AGENDA

President and Board of Trustees
Village of Arlington Heights
Board Room

May 13, 2019

- A. Election of President Pro Tem
- B. Arlington 425 - Highland/Campbell/Chestnut - PC#19-001
Planned Unit Development, Preliminary Plat of Subdivision,
Rezoning from R-3 to B-5, Land Use Variation to allow a Multi-
Family use within B-5 District, Variations

Figure: 3

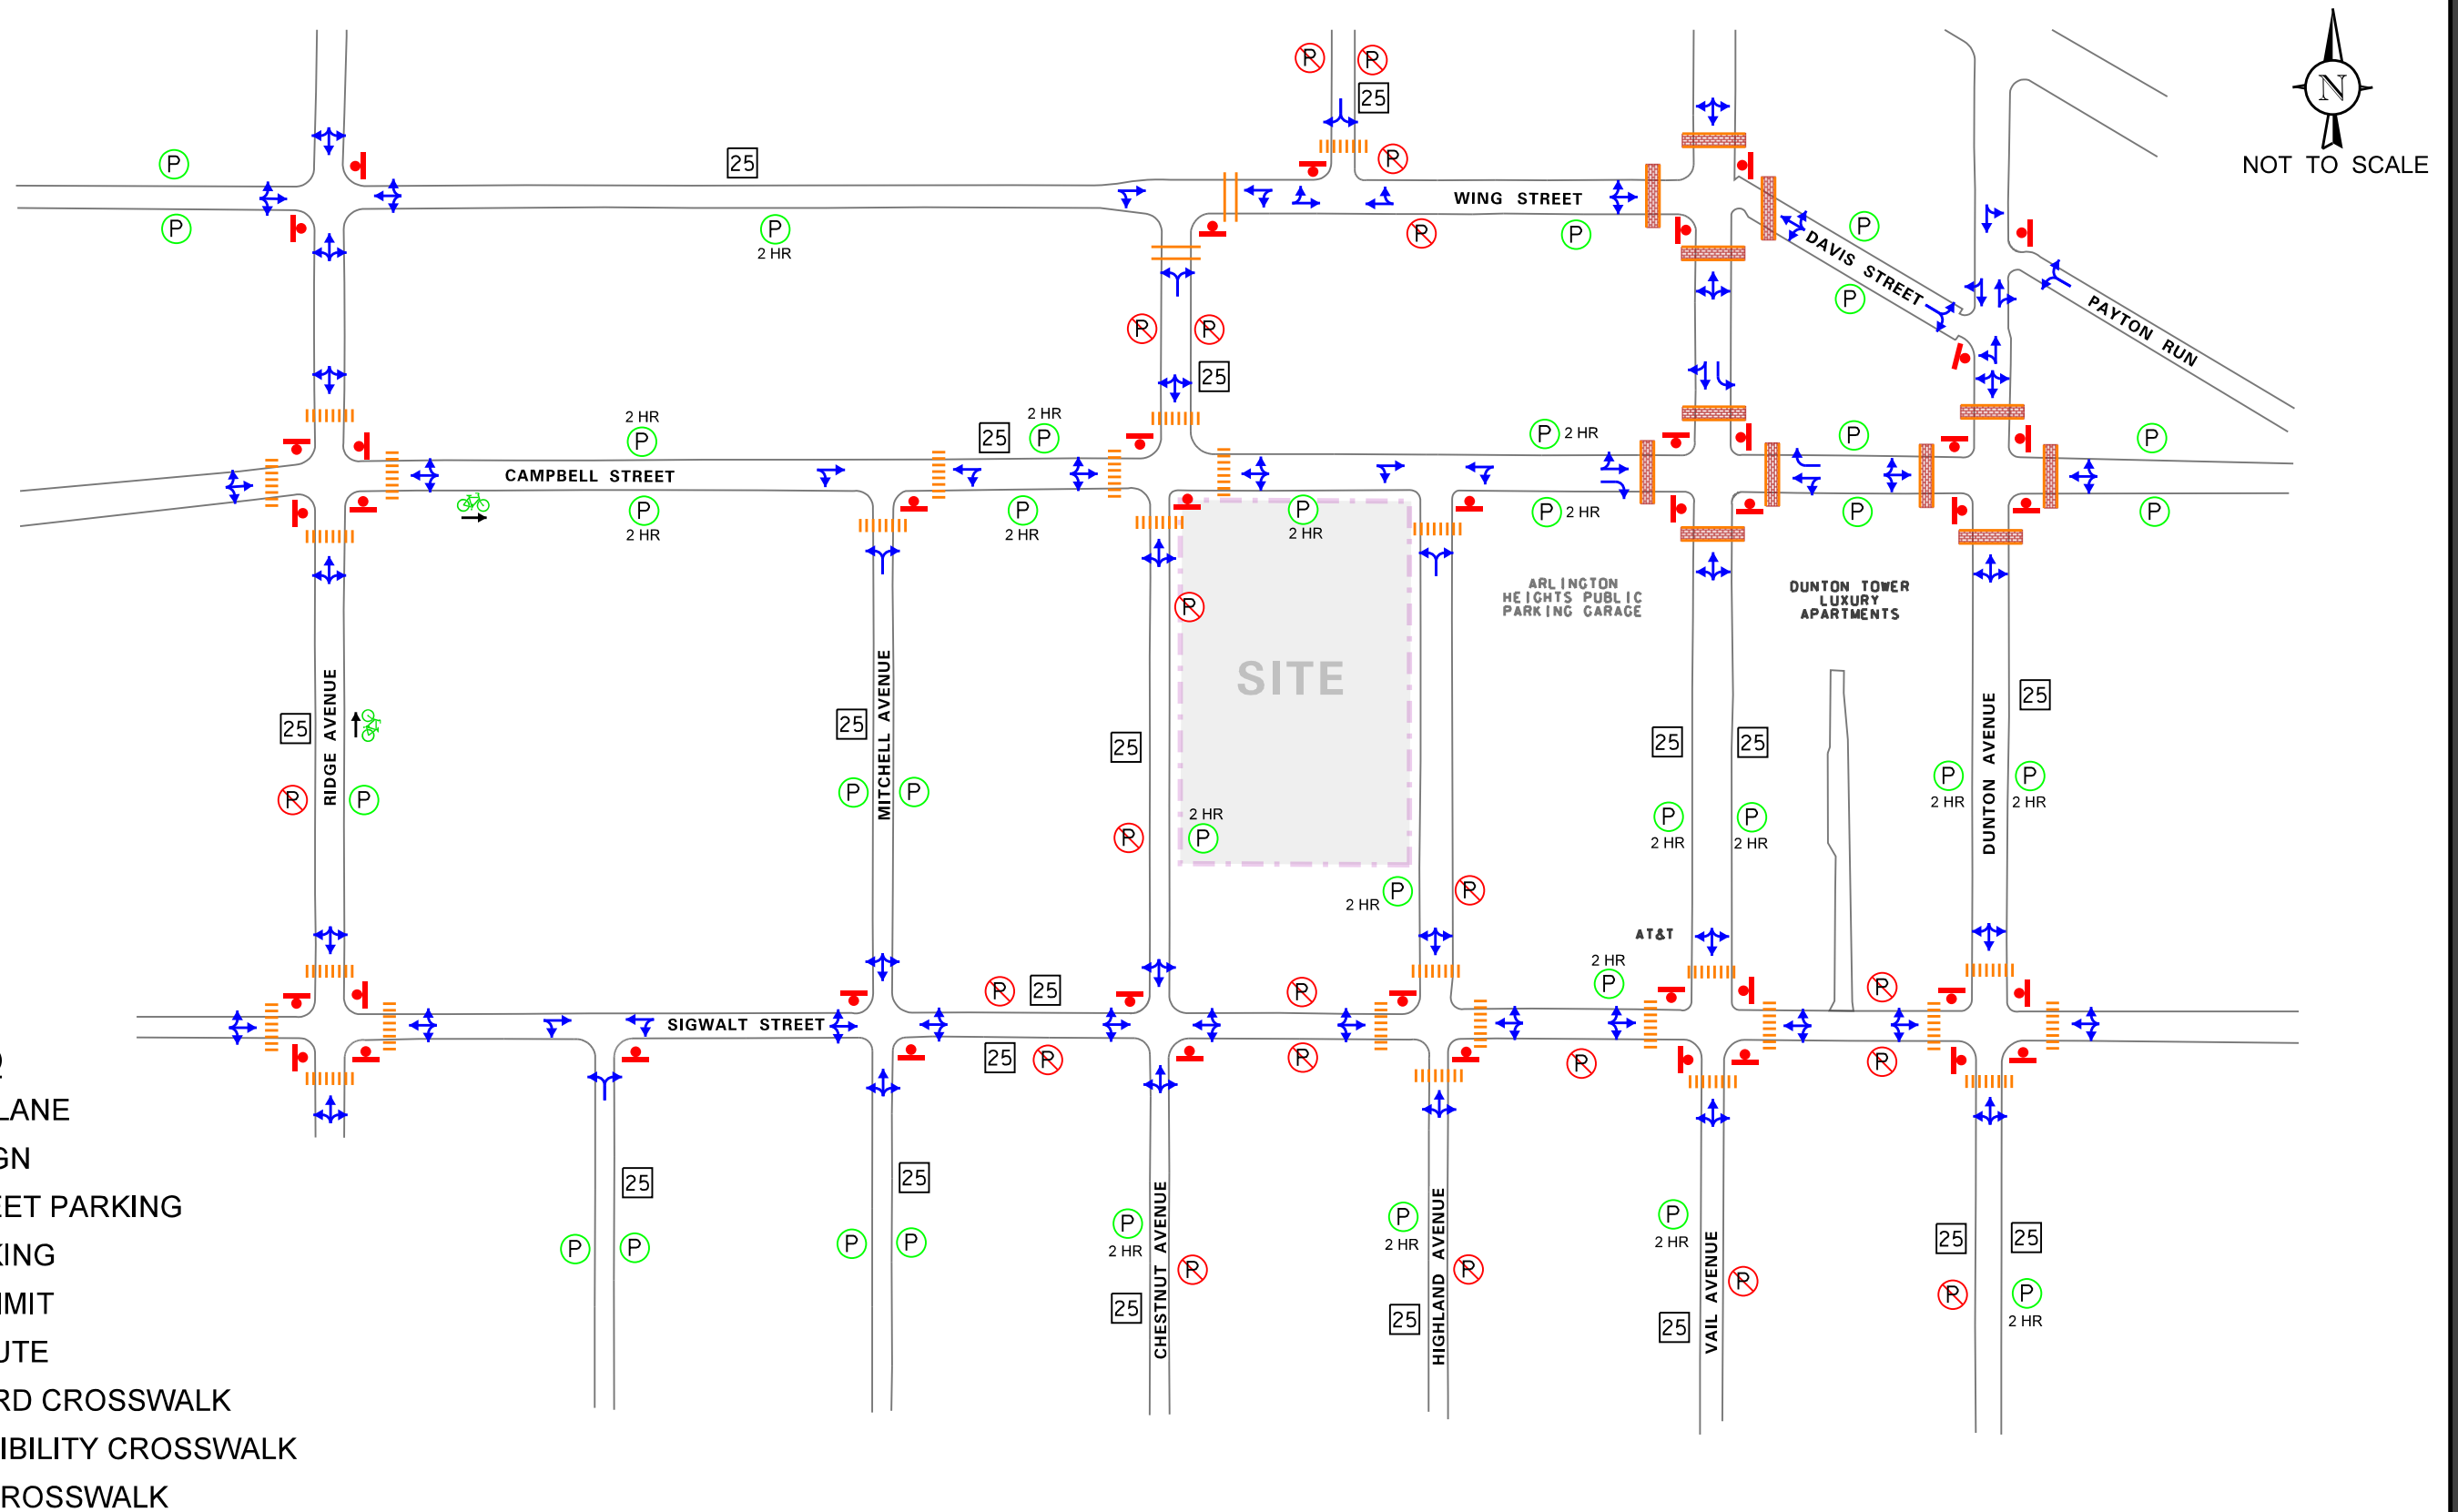
58. Traffic Report Figure 3, is incorrect for the all way stop signage shown at Wing St. and Vail Ave.
59. Traffic Report Figure 4 must be corrected for 'Inset B', which shows three intersecting driveways along the north side of the street. However, the text on page 8 refers to four driveways.

58. Traffic Report Figure 3, is incorrect for the all way stop signage shown at Wing St. and Vail Ave.

Figure 4 illustrates the existing peak hour vehicle traffic volumes.

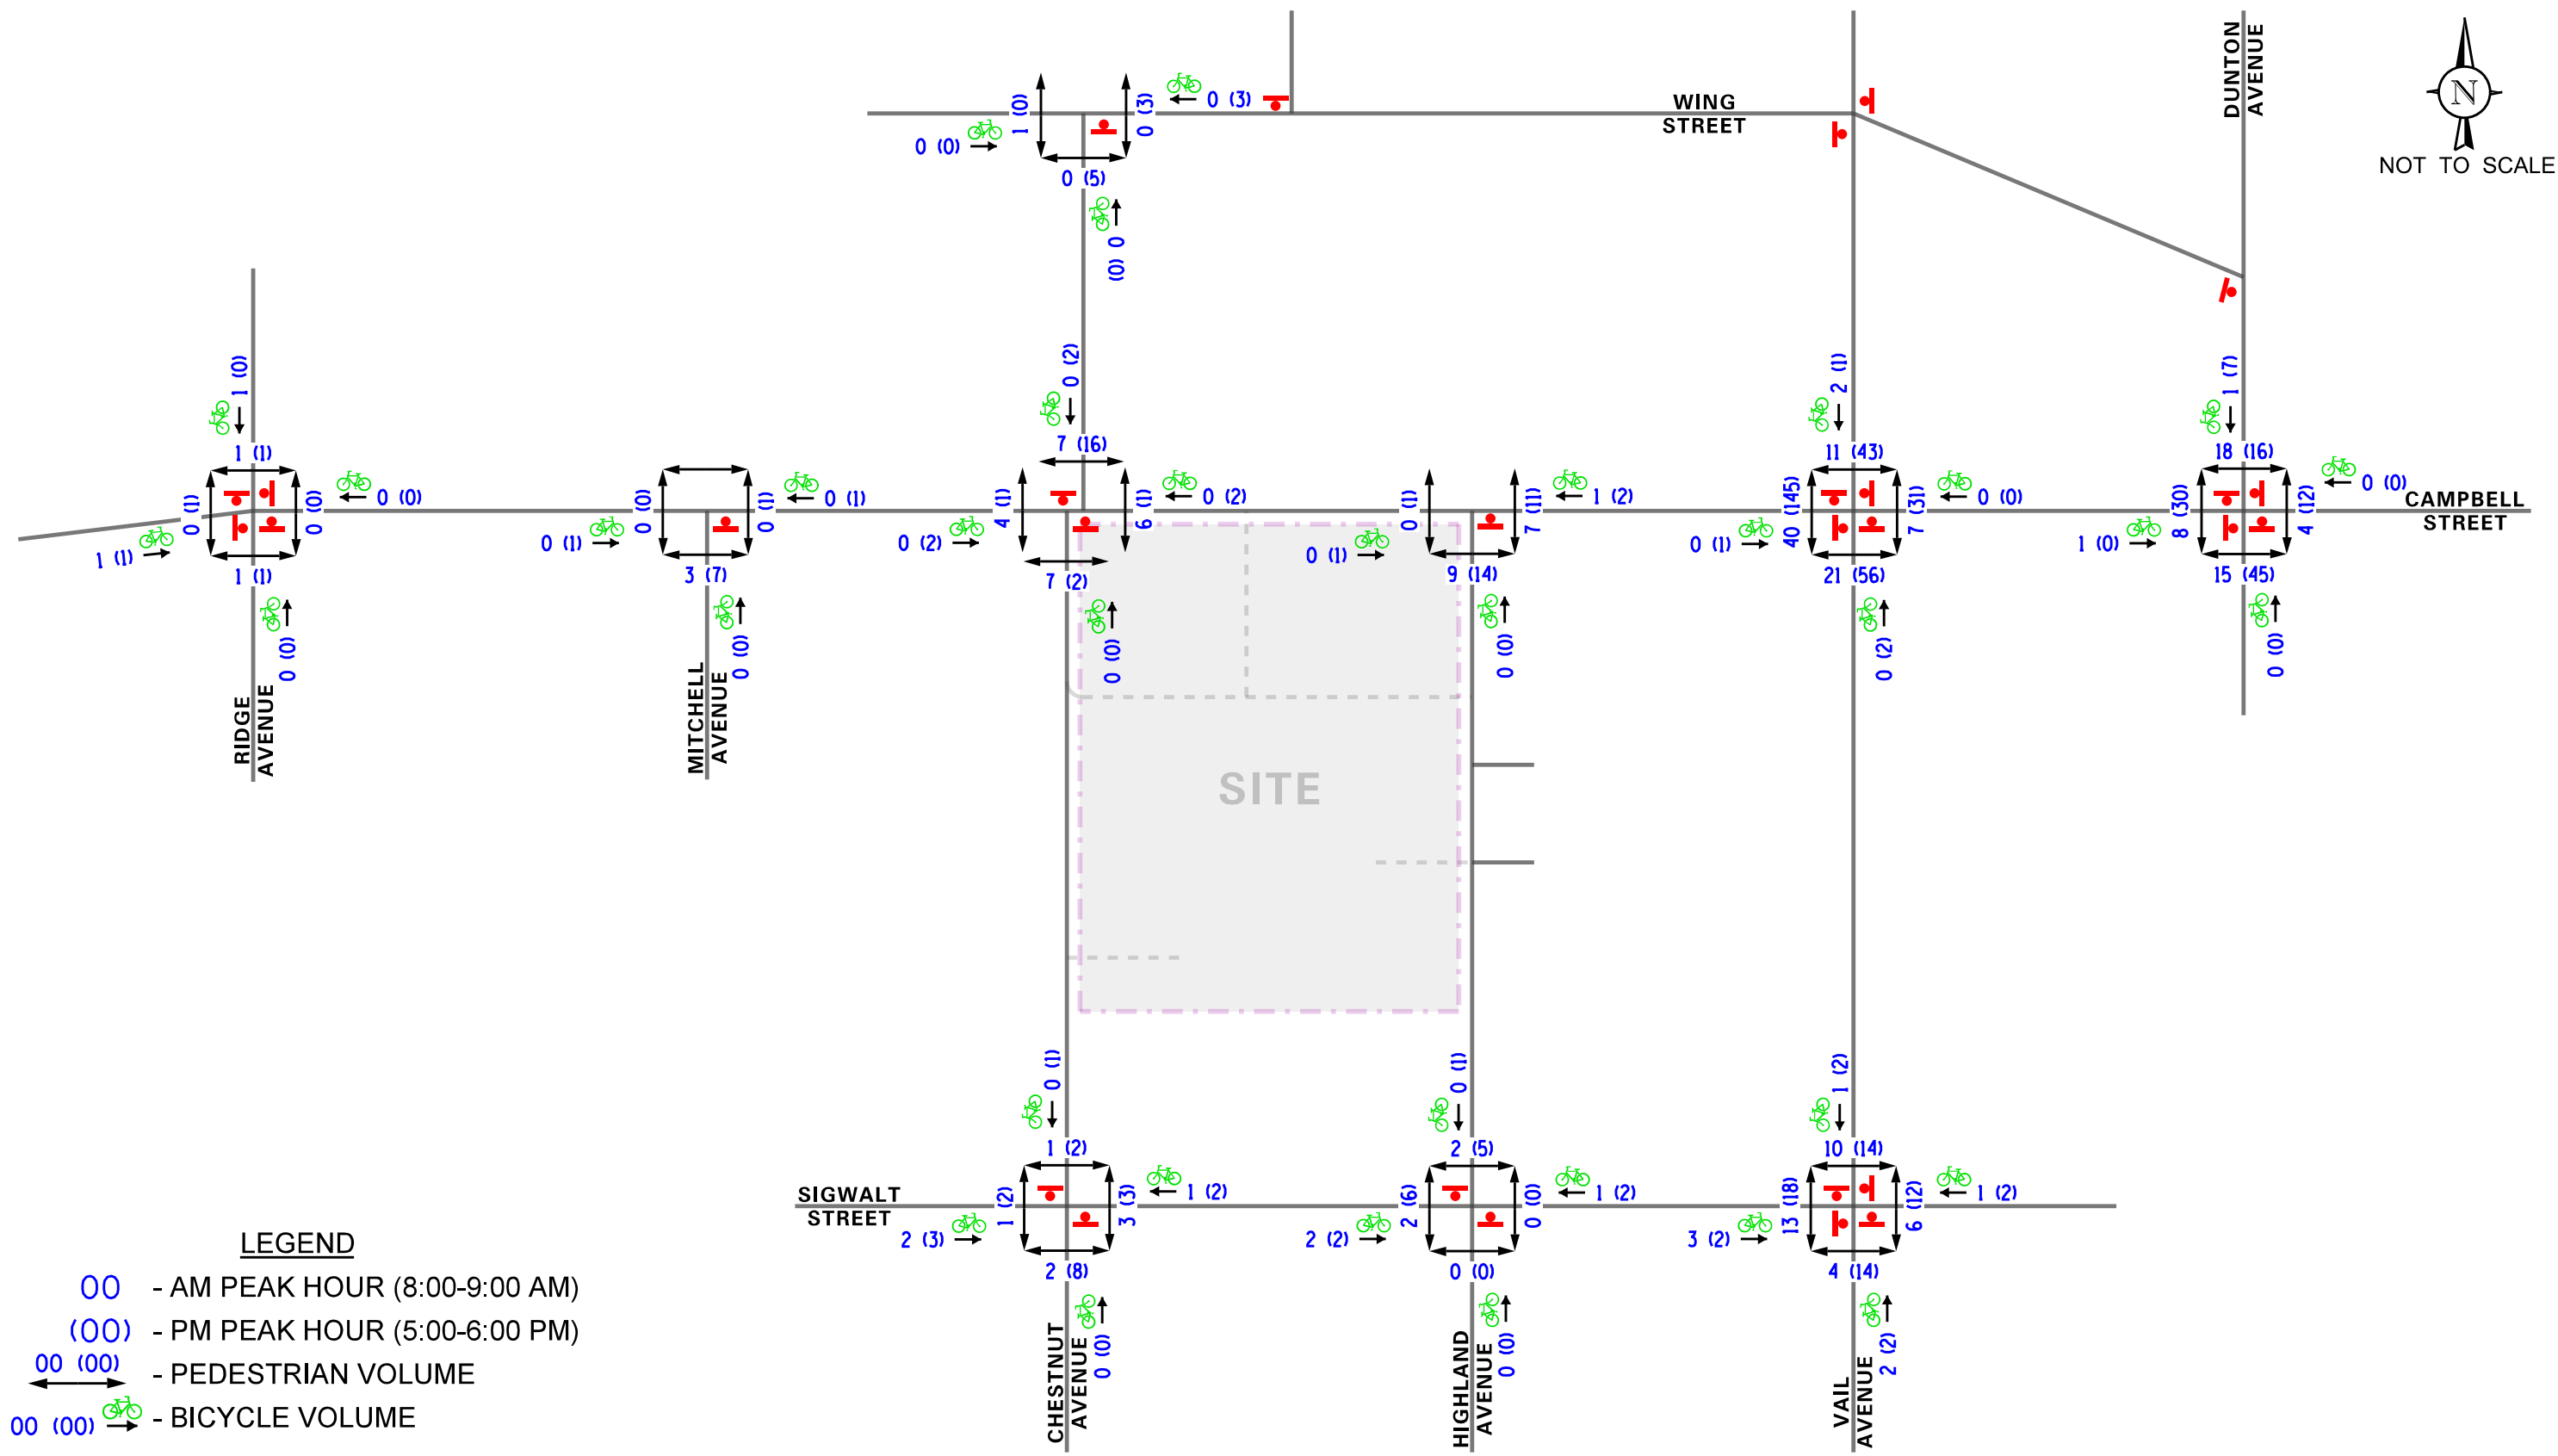
59. Traffic Report Figure 4 must be corrected for 'Inset B', which shows three intersecting driveways along the north side of the street. However, the text on page 8 refers to four driveways.

Figure: 8

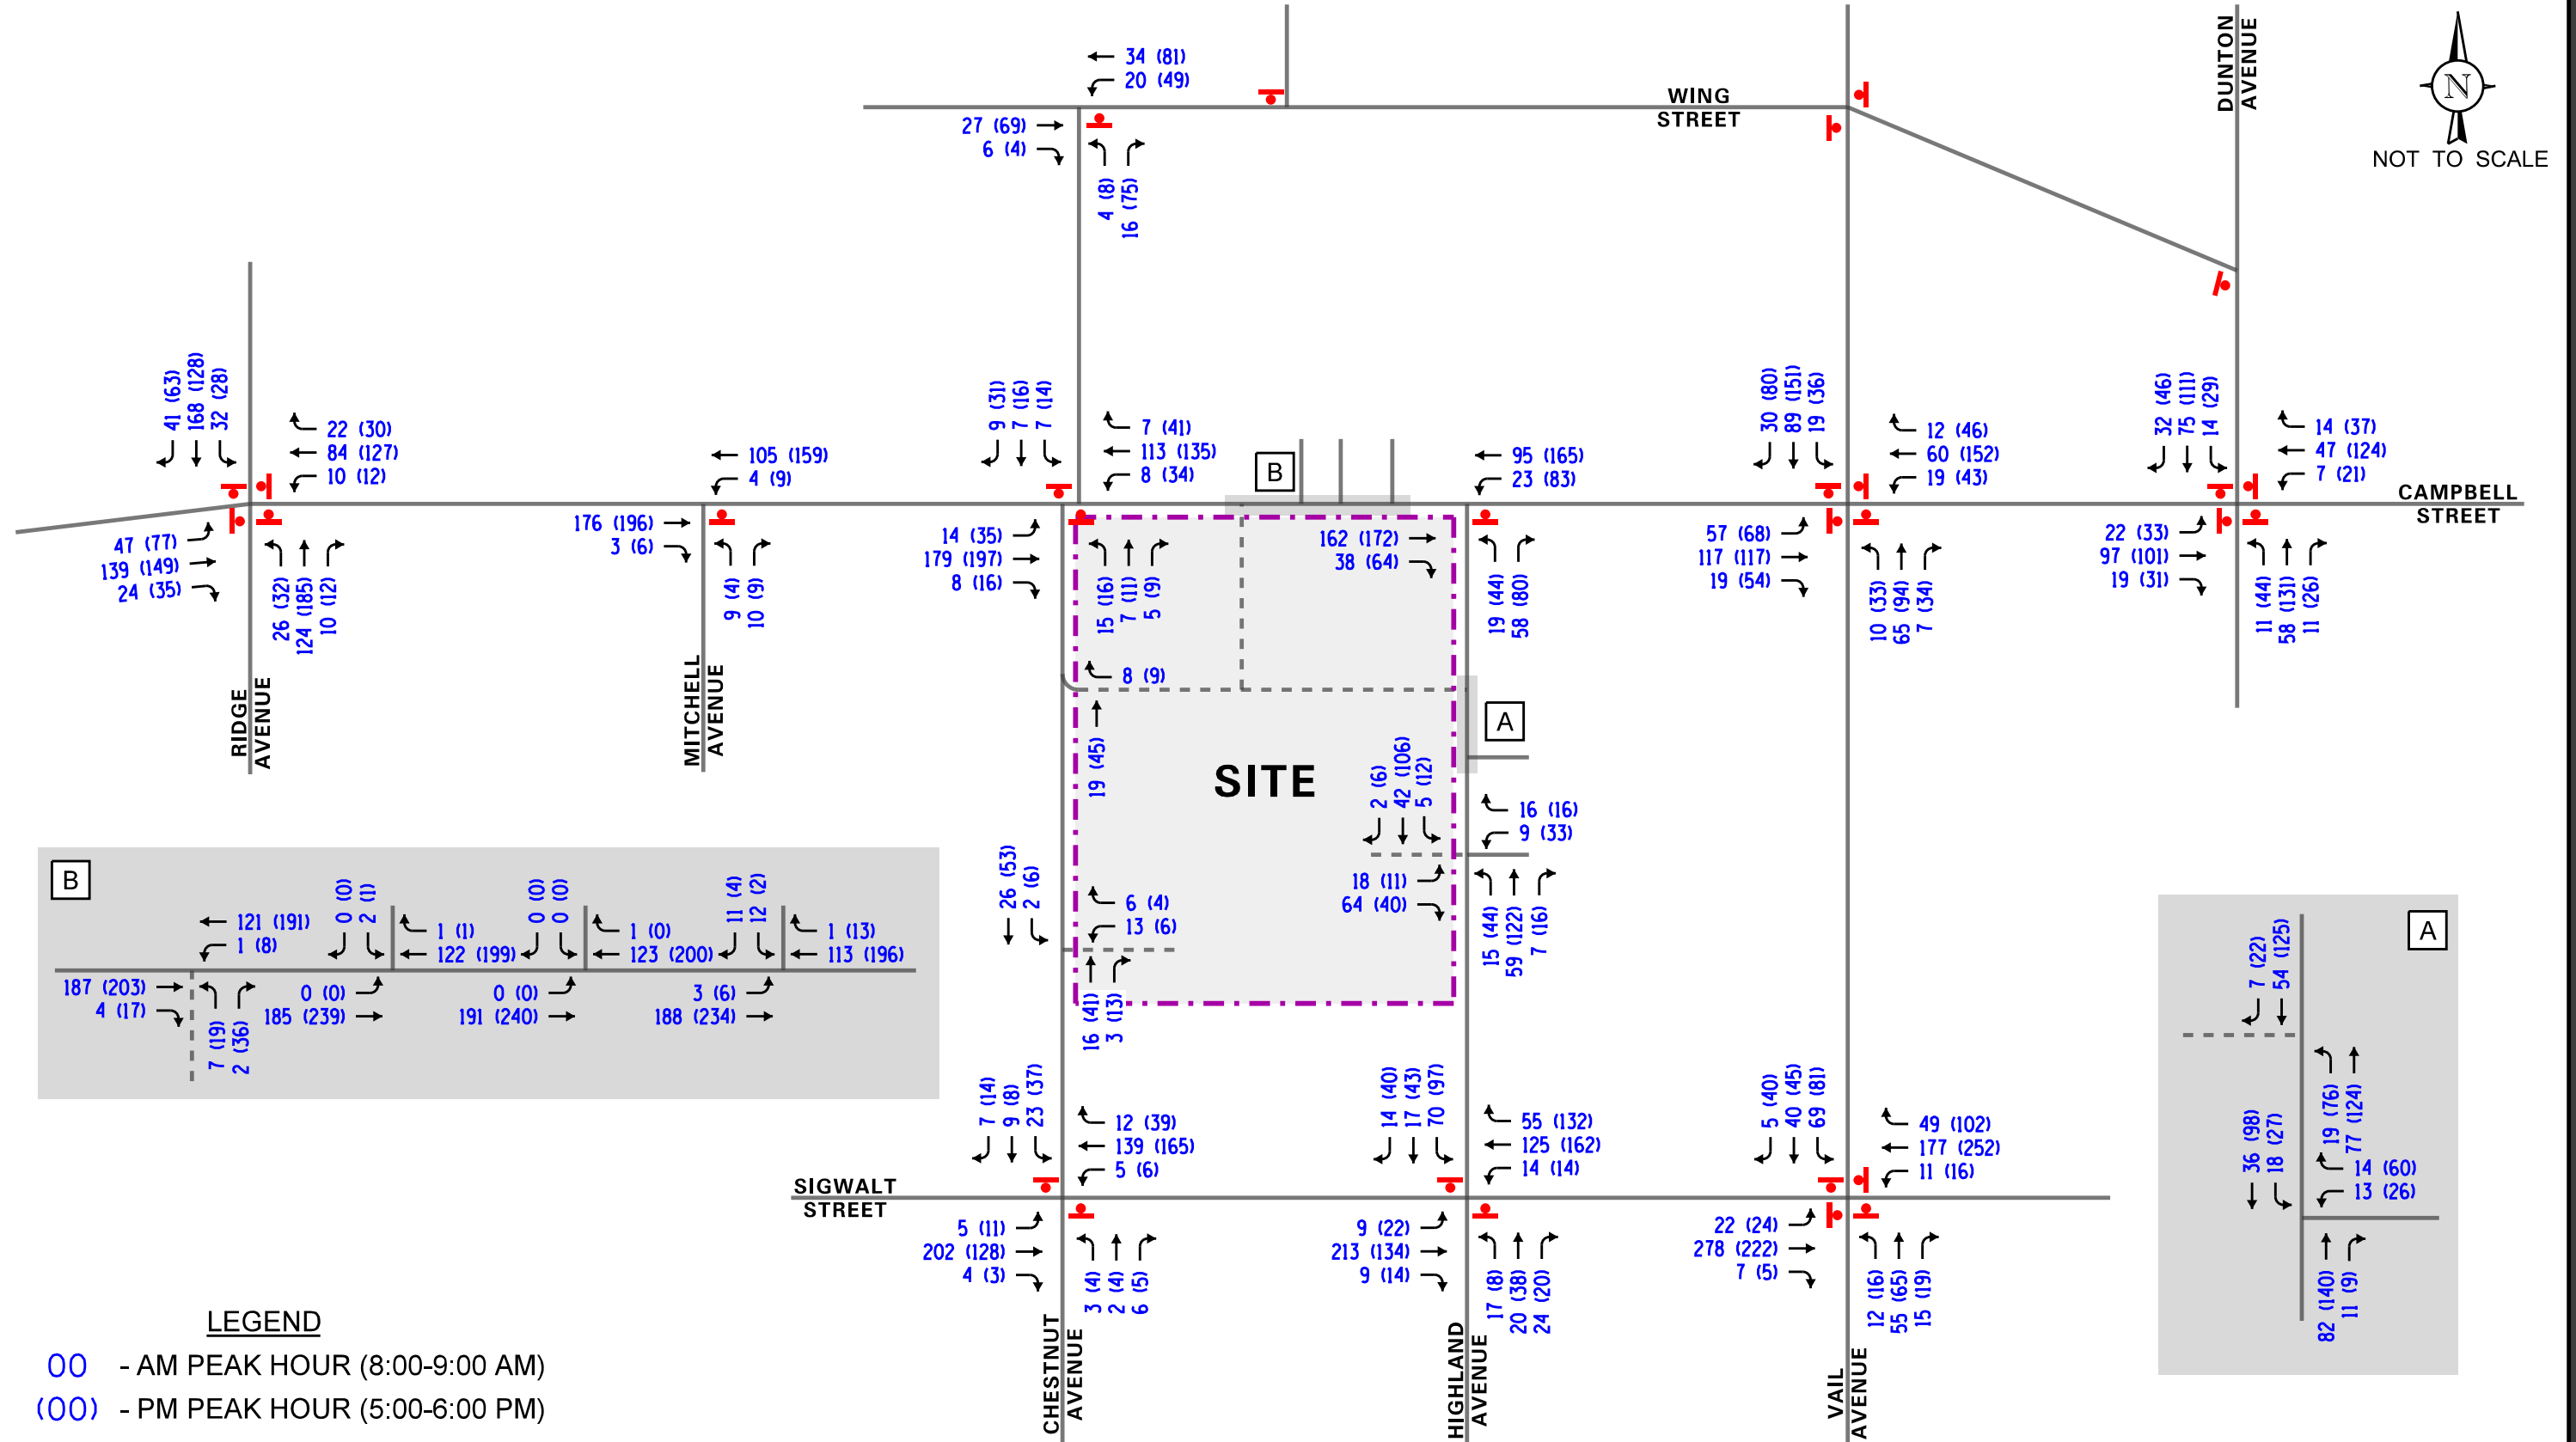
59. The traffic volumes from Figure 7 of the KLOA study, when added to the volumes in Figure 8, do not equate to the volumes shown in Figure 9. Please revise these figures to model the correct traffic volumes.
60. The parking study should be revised to include a parking analysis showing the residential uses parked at 1.5 spaces per unit, but the commercial/office/retail spaces parked per the 2018 Rich & Associates parking study of downtown parking demand (see below):

57. The traffic volumes from Figure 7 of the KLOA study, when added to the volumes in Figure 8, do not equate to the volumes shown in Figure 9. Please revise these figures to model the correct traffic volumes.
